Derby Diocesan Association of Church Bellringers Consultant's Report	Report DDACB 09/05
Church of Saints Peter and Paul Old Brampton – Inspection of Bells	Issue Date 29/08/05

FIGURE 1
RINGING ROOM

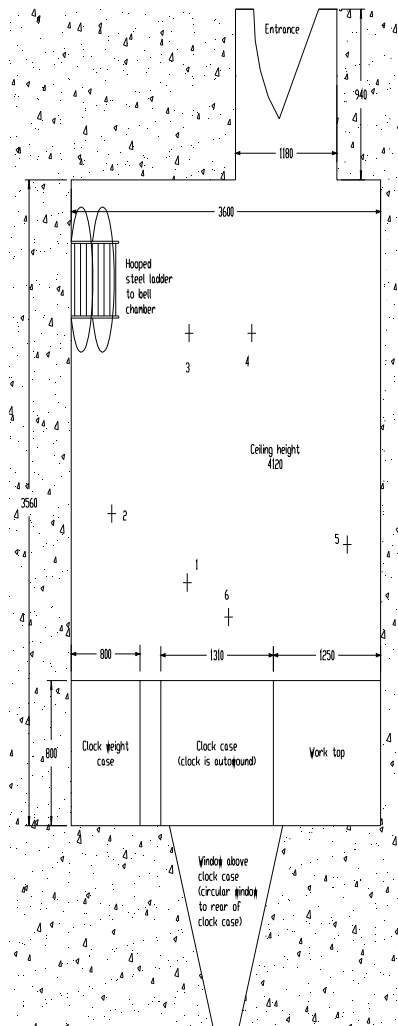
The ringing circle is not good; the ropes to bells 6,1 and 2 lie in a straight line (making rope sight difficult) and the ropes for bells 6 and 1 are too close together. In an ideal world there should be a clear space around each rope of 600mm, particularly on the heavier bells, but rope 6 is too close to the clock case and rope 5 is too close to the east wall.

The ceiling comprises tongue and groove boarding fixed to the underside of the bell chamber floor joists and has a total thickness of about 220mm. A hooped iron ladder gives access to the bell chamber via a trap door in the northwest corner. Since there is no intermediate room between the ringing chamber and the bell chamber, the bell sound levels in the ringing room are higher than desirable. Sound levels were measured at 77 - 82 dB(A) as shown in the table.

To maintain satisfactory voice communication between ringers and remain within legislative guidelines on sound levels, 80 dB(A) is the absolute maximum that is considered tolerable in ringing rooms for general ringing. The target is 10 dB(A) less than this, specifically to achieve ringing room sound levels for each bell of between 68 and 72 dB(A) with ideally no more than 3 dB(A) spread between all bells. Much of the sound comes through the large ceiling bosses and the unsealed trap door. Also the old weight shaft acts as a

FIGURE 2
BELL CHAMBER

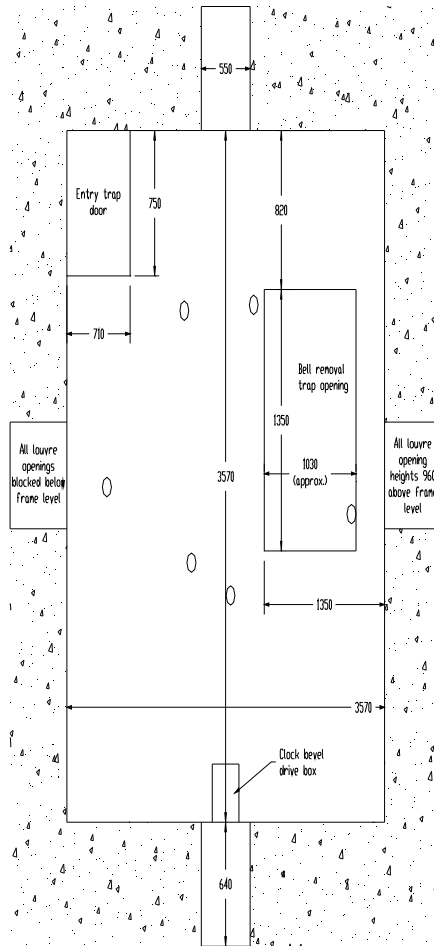
The bell chamber is well lit by electric lights both below and above the bell frame. There is a clearance of about 700mm between the floor and the underside of a steel beam which shores up the bell frame foundation beams. This is an obstacle to accessing the bells for maintenance work and regular sweeping of the floor would make this task more pleasant! The top of the frame is 2230mm above the floor and is reached via a short wooden ladder in the pit of bell 2. This ladder is missing one rung, making it unsafe, and should be repaired as soon as possible. The confined space of this pit makes negotiation of the ladder a challenge in any case!

The floor boss for the rope from bell 2 comprises a short box section. One side of the box has become detached and is fouling the rope. This must be rectified as soon as possible.

The bell chamber floor has suffered for many years from dampness resulting from ingress of rainwater. Although ingress of rainwater is now resolved, it is probable that the joist ends in the west wall have rotted to the point where they cannot safely transmit the floor weight into the wall. A 152 X 76mm rolled steel joist, set north/south in the ringing room walls, supports this side of the floor. There is serious rot evident in the tongue and groove boarding in the centre of the floor and a lack of support for the floor under the tenor bell. It seems likely that some joists may have partly succumbed to dry rot at mid span and it is recommended that the boards should be lifted to enable a structural survey to be carried out.

FIGURE 3
BELL FRAME

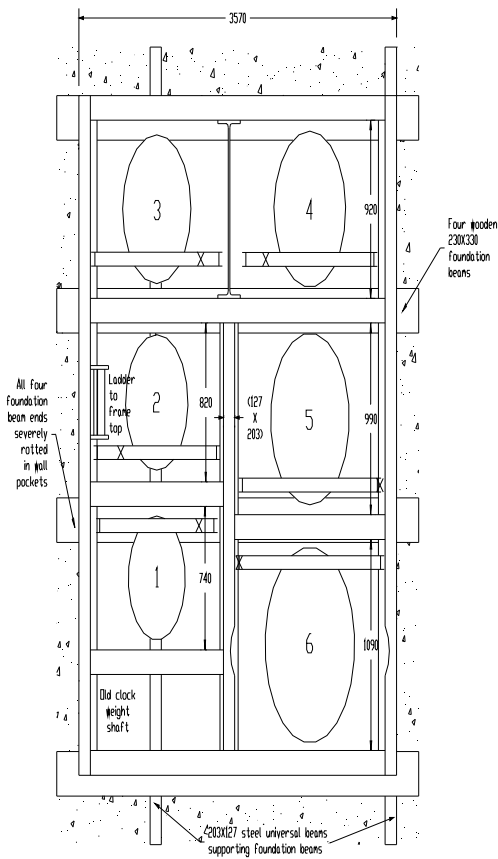
The frame is a conventional low-sided wooden (pine?) frame installed in 1887 and rests on four large foundation beams set east/west in the tower. It is well braced by tie rods and metal plates. Viewed from the underside, two of the tie rods on the truss between bells 5 and 6 appear to be loose and ought to be tightened.

The foundation beam-ends in the west wall have been severely damaged by dry rot to the point where some are no longer able to transfer frame loads into this wall. An alternative load path has been provided by installation of two 203 X 127mm universal steel beams set north/south under these wooden foundation beams. One of these steel beams is set against the east wall and the other set as far west as the clock weight pit would allow. Distortion of one of the two centre wooden foundation beams means that it provides no support to the west side of the frame under the treble and second bells. This does not seem to be a problem since there is very little frame movement when any of the bells is rung. However this beam is heavily affected by dry rot not only at its beam-ends but also on top under the treble bell and it is this which has caused the beam to distort away from the frame. It is also this considerable rot which has infested the wooden slider pivot block as described in section 4.8. It is strongly recommended that when repairing the slider this dry rot should be killed before it spreads further.

FIGURE A1
SUGGESTED NEW
BELL CHAMBER
FLOOR
CONSTRUCTION

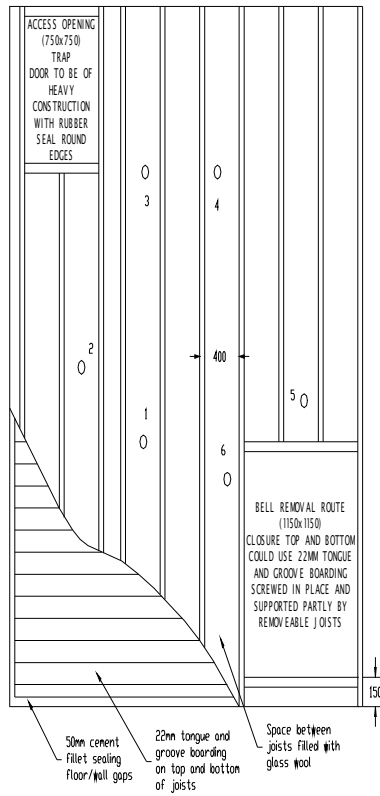
It is recommended that the new floor should be of double skin construction, i.e. wooden joists clad top and bottom with 22mm tongue and groove boards, and set at a height above the ringing chamber floor of no less than 3,7 metres. (NB Any affect on the auto-wind mechanism for the clock needs to be checked since the new floor will not only be lower but will also completely sever the old clock weight shaft). As shown in figure A1 the joists are best run in a north/south direction to give maximum clearance for the bell ropes and their floor/ceiling bosses. The joist ends could be supported on full width galvanised steel angle sections positioned within the thickness of the floor and fixed to the north and south walls by chemical anchors. The edges of the floor should be sealed against the walls by a 50mm cement or mortar fillet.

The entry trap door in the northwest corner should employ 22mm tongue and groove boarding in its construction and should be completely sealed against the floor surface by a rubber seal around its edge. It should be hinged on its north or west side.

There must be provision for a bell removal path, as shown in figure A1, but since this may only be used once every 100 years or so it is not necessary to incorporate a proper trap door. Double skin construction must be maintained but all that is necessary is to use easily removed 22 mm tongue and groove boarding and supporting trimmers all held in place by (stainless steel?) wood screws. It would be advantageous to seal the gaps round the edges of the removable boards with silicon rubber or similar.
